DOWNTOWN CORRIDOR IMPROVEMENTS
CITY OF LAS VEGAS DEPT. OF PUBLIC WORKS
LAS VEGAS, NEVADA

STORM DRAIN
PLAN AND PROFILE
STA.55+90 TO STA.58+00

DWG. NO.
107-V-2288
FILE NO.
0135.0105
SHEET 19 of 51
SD-2

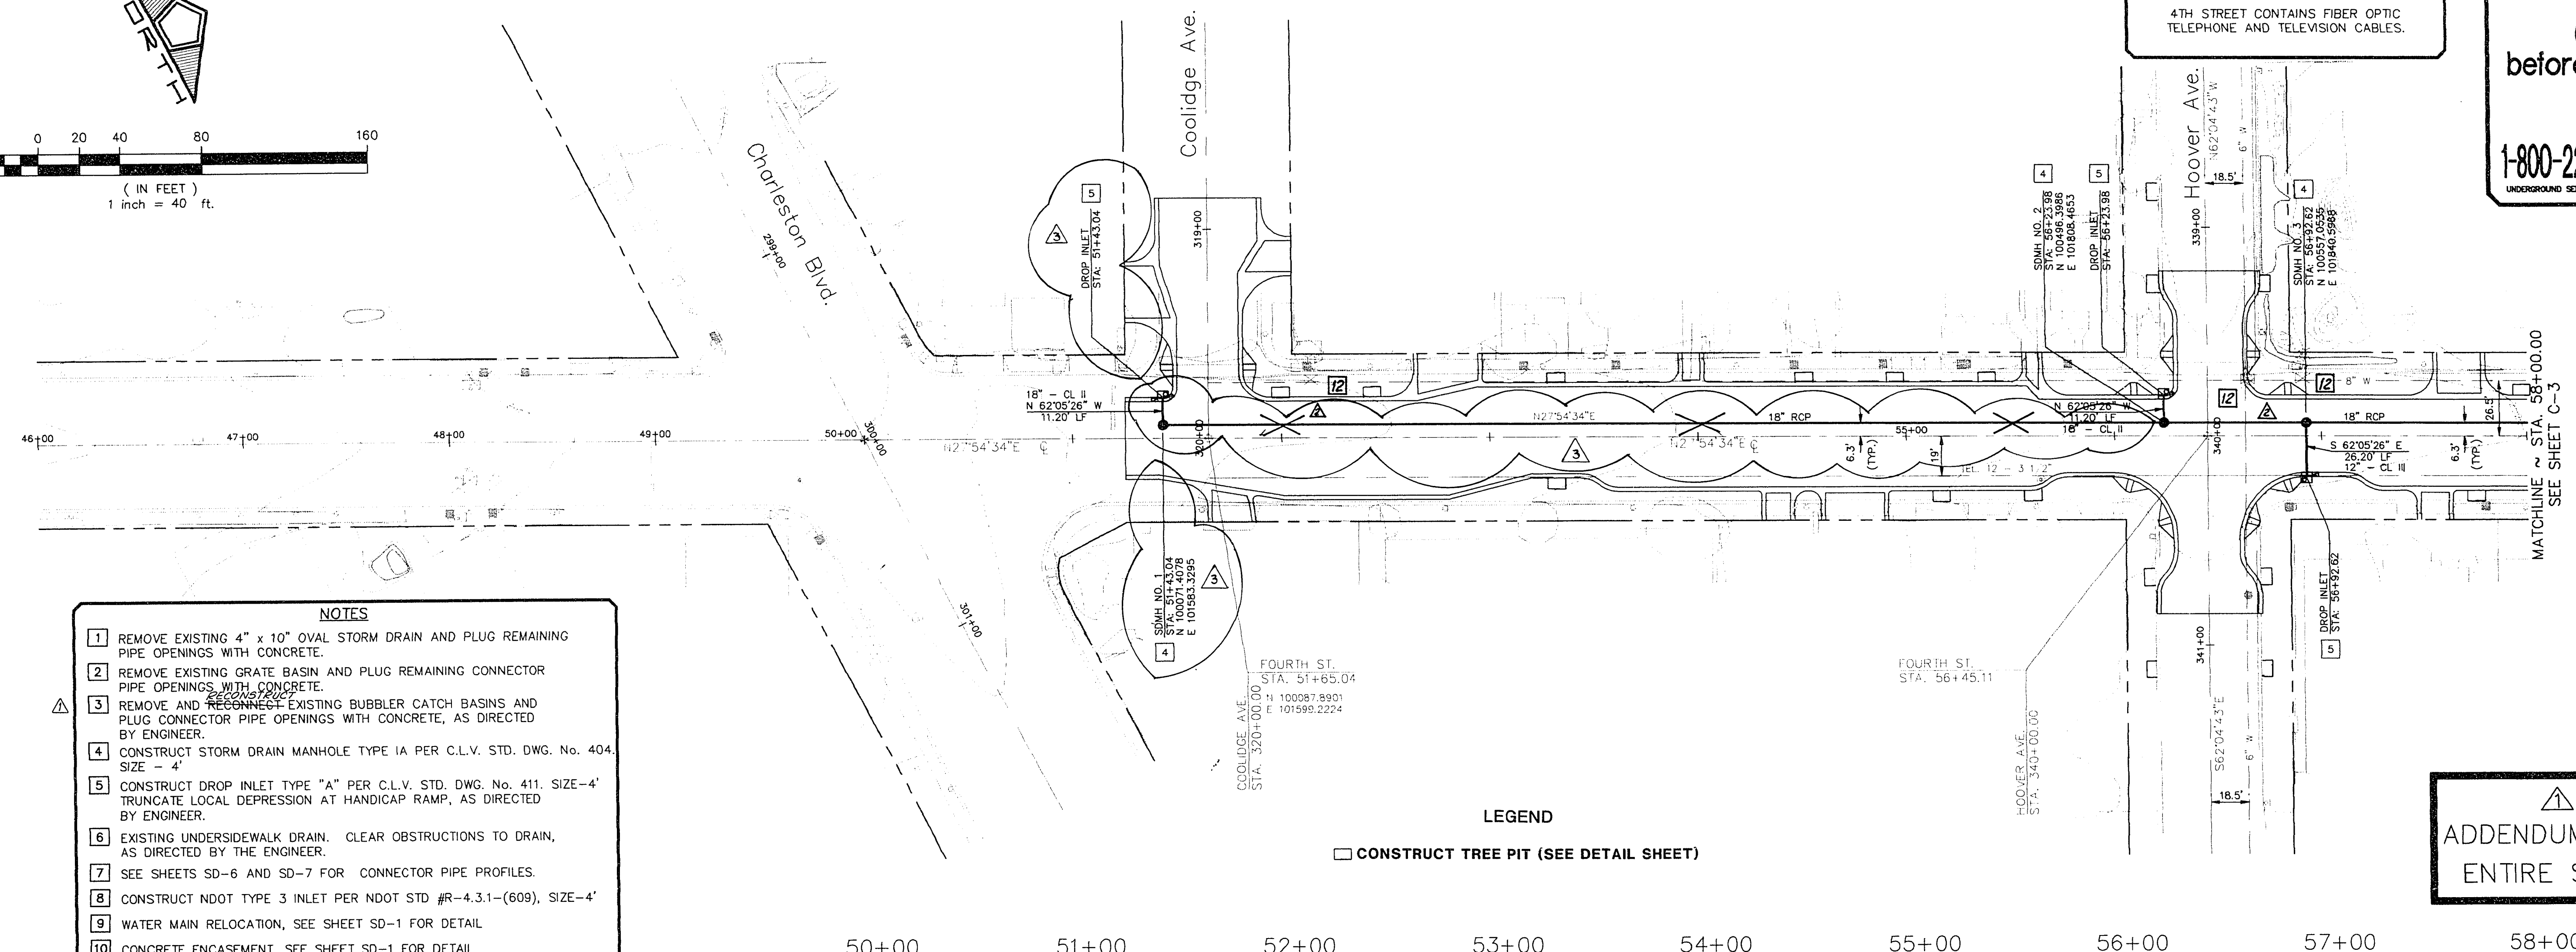
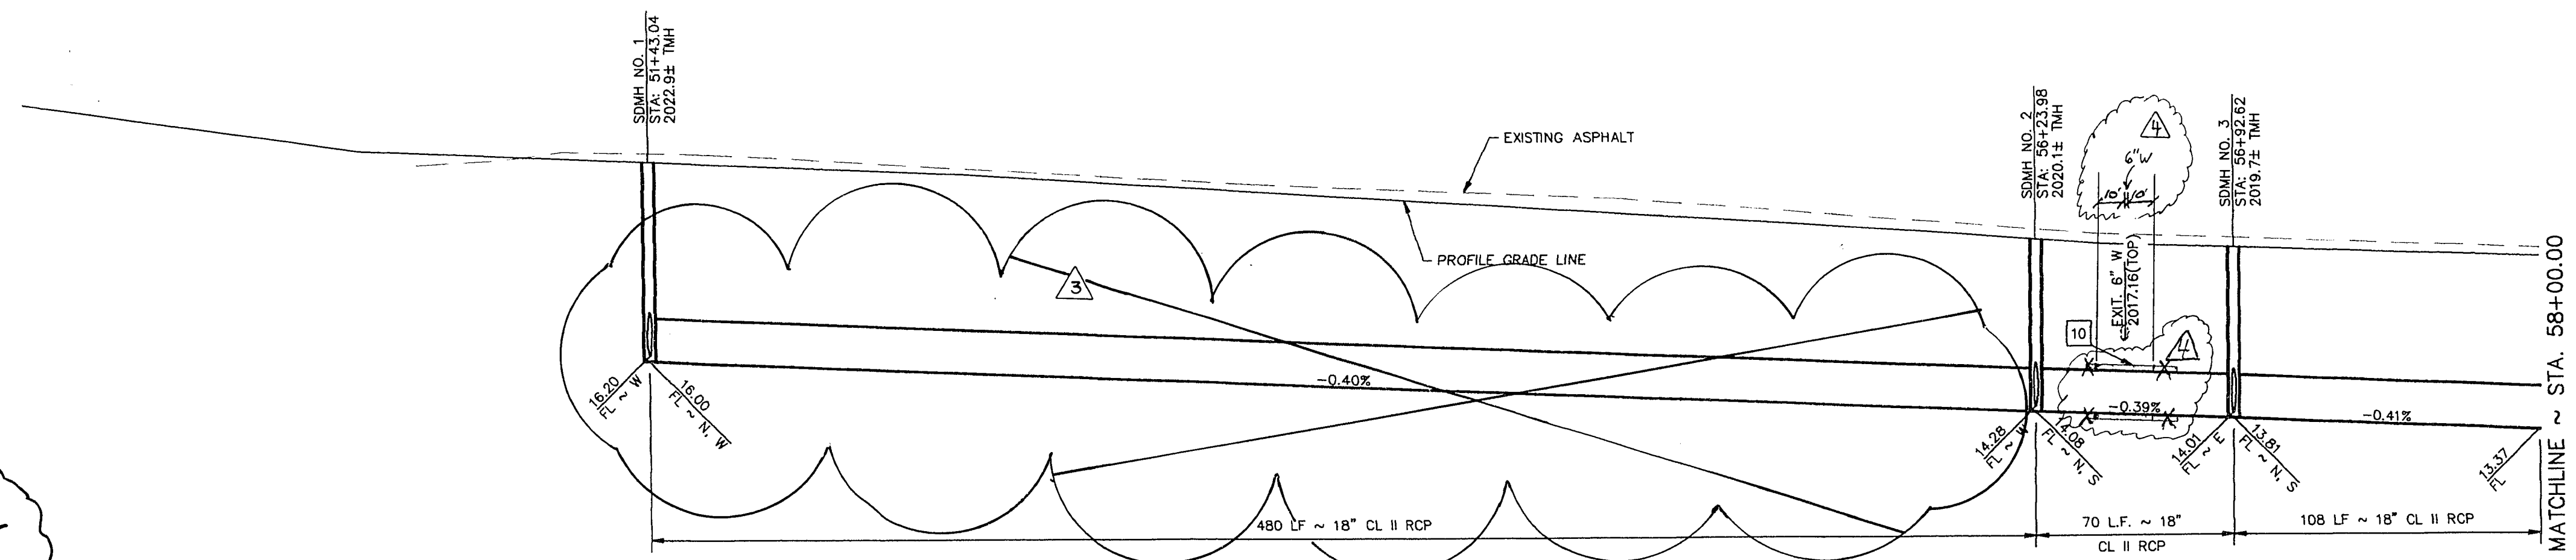
△ CLEARIFICATION, CONCRETE ENCASUREMENT TO EXTEND 10' EITHER SIDE OF WATER LINE WALL. 4-20-95

NO.	REVISIONS	DATE	BY
1	REVISION NO.1 ISSUED AS ADDENDUM NO.1, ENTIRE SHEET. MODIFICATIONS MADE TO NOTES, CONCRETE ENCASUREMENT ADDED TO PROFILE, CL II RCP ADDED TO PROFILE, 0.2' DROP IN INVERTS OF CONNECTOR PIPE.	12-10-94	DBB
2	PER L.V.V.W.D. REVIEW	1-13-95	LAB
3	REVISION NO.3, ISSUED AS CCO, REMOVE PIPE BETWEEN STA 56+23.98 TO STA 51+43.04, C.B. & M.H. @ STA 51+43.04.	1-31-95	DBB
